SERVICE BULLETIN

UPGRADE OF 40-97E WHEEL ASSEMBLY TO 40-97F CONFIGURATION

- EFFECTIVITY:** Parker P/N 40-97E Wheel Assemblies equipped with Grease Seal Felt P/N 154-00300 and Grease Seal Rings P/N 153-00400 on Inboard Wheel Half.

Figure 1 - Converting 40-97E Wheel Assembly to 40-97F Configuration

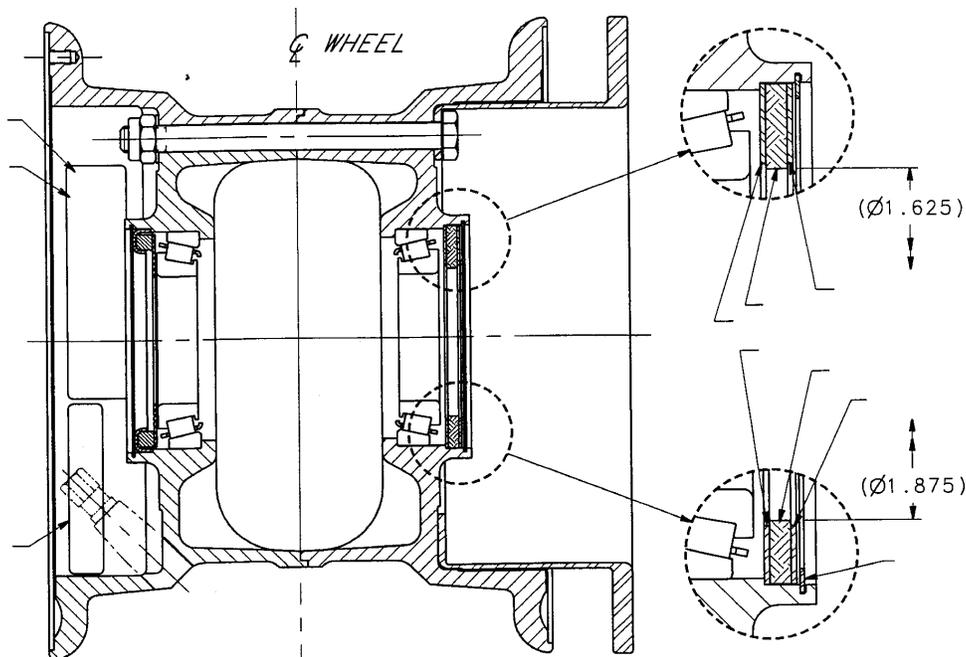
1. The following components must be removed from the existing P/N 40-97E Wheel Assembly and discarded: (See Figure 1 for location of components)

<u>PARKER P/N</u>	<u>DESCRIPTION</u>	<u>QUANTITY</u>
155-00100	Ring, Retaining	1
153-00400	Ring, Grease Seal	2
154-00300	Felt, Grease Seal	1
166-02100	Nameplate (located on Outboard Wheel Half)	1

2. Prior to installing new Grease Seal Rings and Grease Seal Felt on Inboard Wheel Hub, lightly saturate the Grease Seal Felt, P/N 154-01600 with SAE10 oil.
3. Install Grease Seal Rings P/N 153-01600 and Grease Seal Felt P/N 154-01600 on Inboard Wheel Hub as shown in Figure 1 and secure with Retaining Ring P/N 155-00100.
4. Install new nameplate P/N 166-19700 on Outboard Wheel Half as shown in Figure 1. Note: The manufacturing date code for all replacement nameplates will be coded with the current date that the nameplate is printed. Example: A nameplate that is printed in April of 1997 will be identified as Mfg. 04R97 (An "R" between the month and year indicates that this is a replacement nameplate).
5. Install P/N 166-20000 "Warning" Nameplate adjacent to the valve.
